RE: Hollymead Town Center Area A2 – (ZMA 2007-001) Request for Variation
Variation to Community Street Connection b/w Area A2 & Hollymead Shopping Center

Variation– Modification to the Community Street Connection between Area A2 and the existing Hollymead Shopping Center

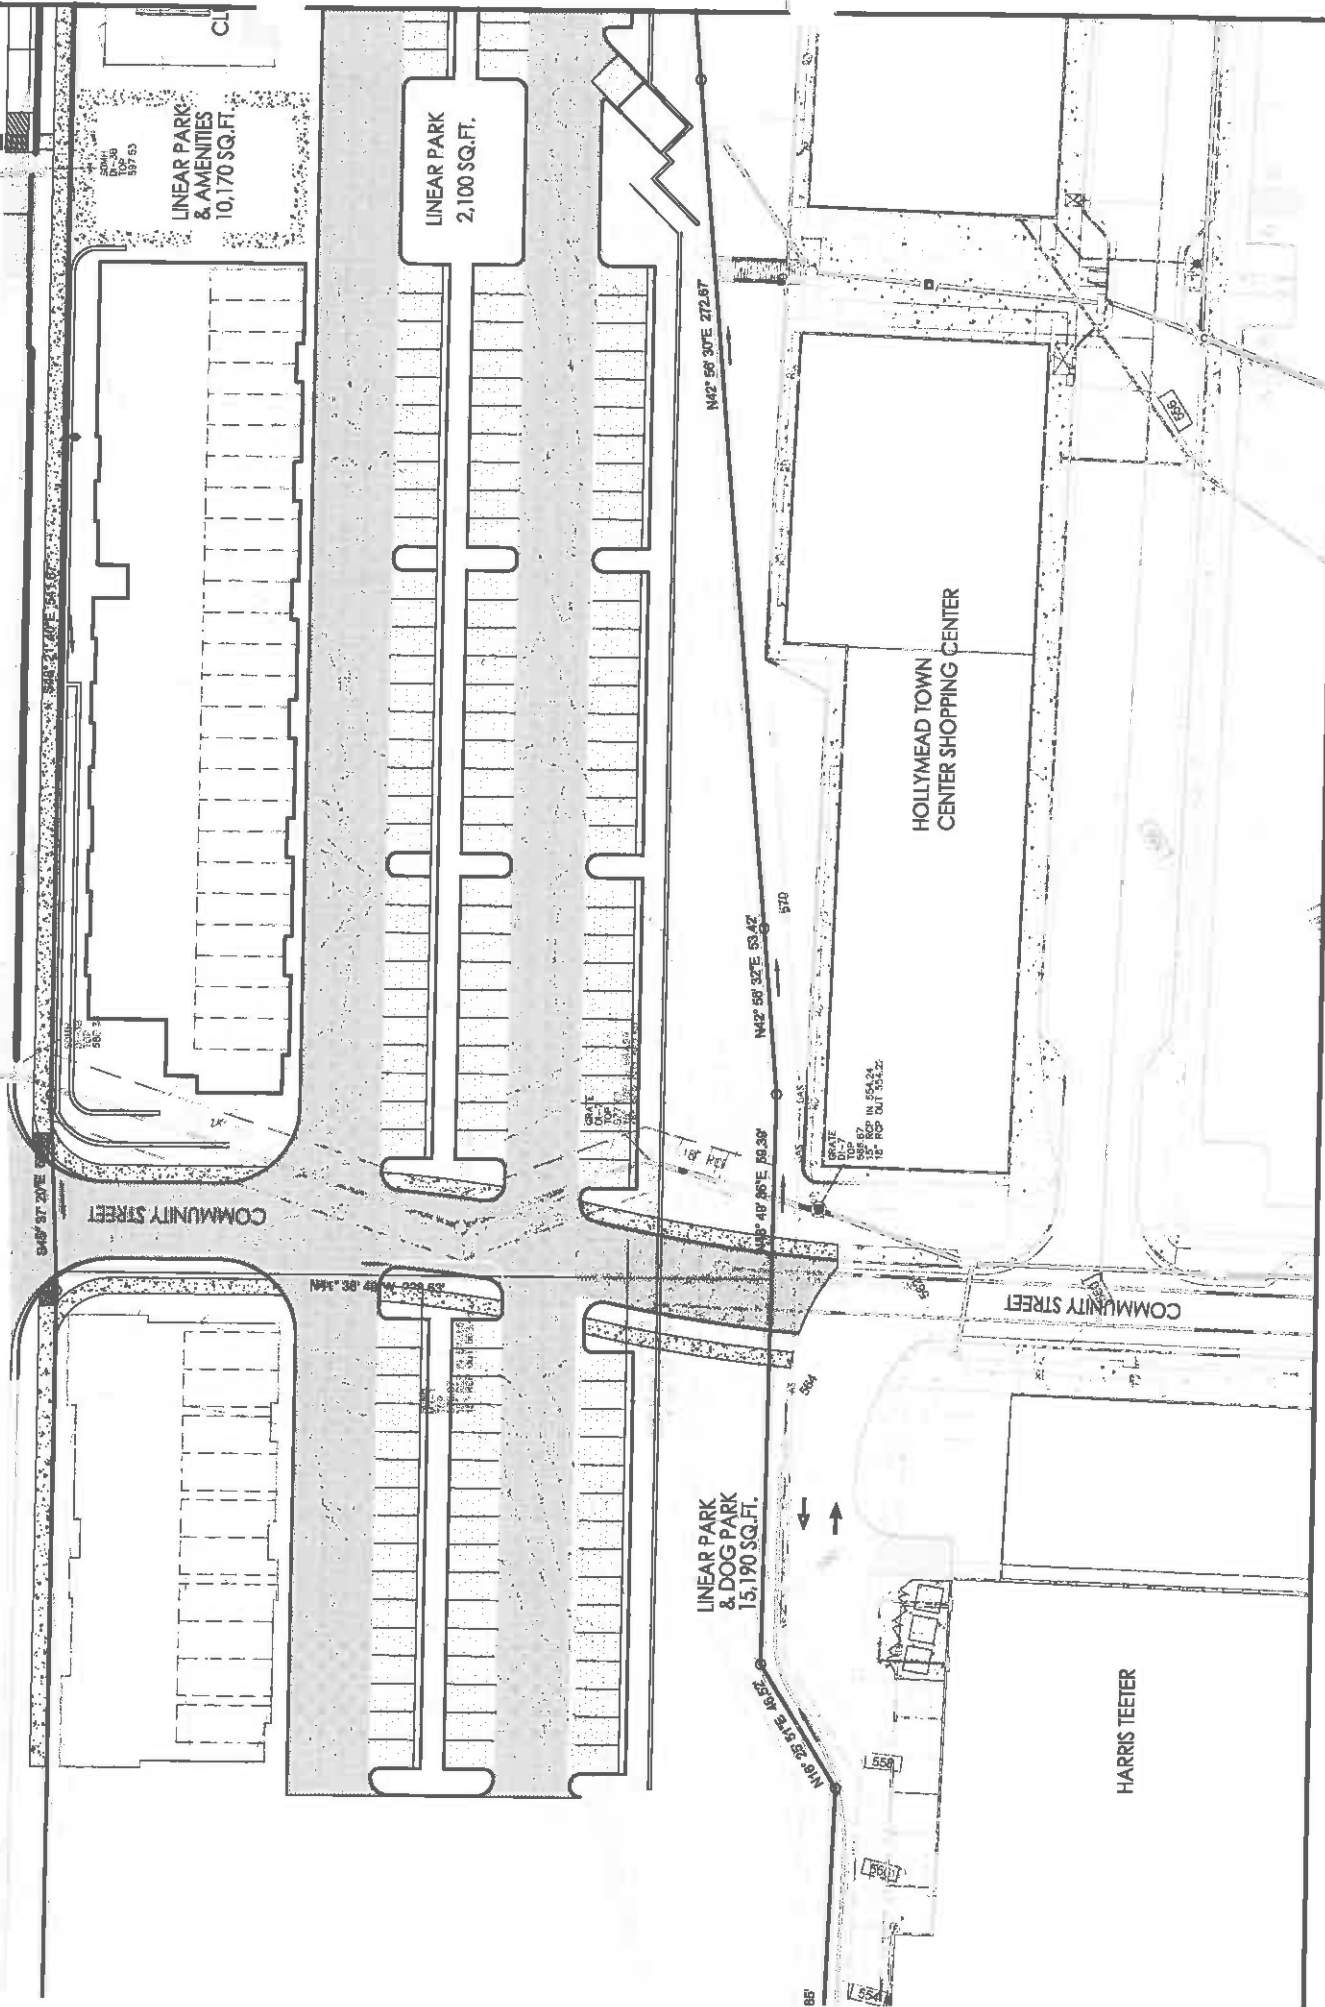
A variation is being proposed for this project to terminate Community Street within the parking lot for Area A2, and provide a pedestrian/bicycle access from Area A2 to the existing shopping center, in lieu of the proposed vehicular connection. The pedestrian/bicycle access would include an 8' wide paved / concrete ADA accessible pathway between the existing shopping Center and Berkmar Drive, along with a 5' concrete sidewalk and steps for pedestrians. These connections, as shown on Exhibit C, will provide a much better pedestrian and bicycle connection between the two development areas than the 12% roadway. If Community Street is

extended between the two developments, as currently designed, it will primarily be a vehicular connection only. A 12% roadway is not a pedestrian or bicycle friendly connection. The intent of this connection is to promote access between the residential development of Hollymead Town Center and the existing shopping center. However, with grade elevations along the 12% roadway, this will promote more vehicular traffic than pedestrian/bicycle traffic between the areas. A 12% roadway is not safe for bicycles as a connection between the developments and is not a desirable slope to walk up or down for pedestrians who may be pushing a stroller, carrying groceries, or just out an enjoyable walk.

As shown in the attached variation, an ADA accessible pathway could be installed between Area A2 and the existing shopping center. The cost for the proposed construction of the accessible ramp and concrete steps is comparable to the roadway connection; however, it promotes pedestrian/bicycle access between the developments in lieu of a vehicular access. Towncenter Drive would serve as the vehicular access between the developments, and this roadway connection is approximately 500 linear feet to the south of Community Street.
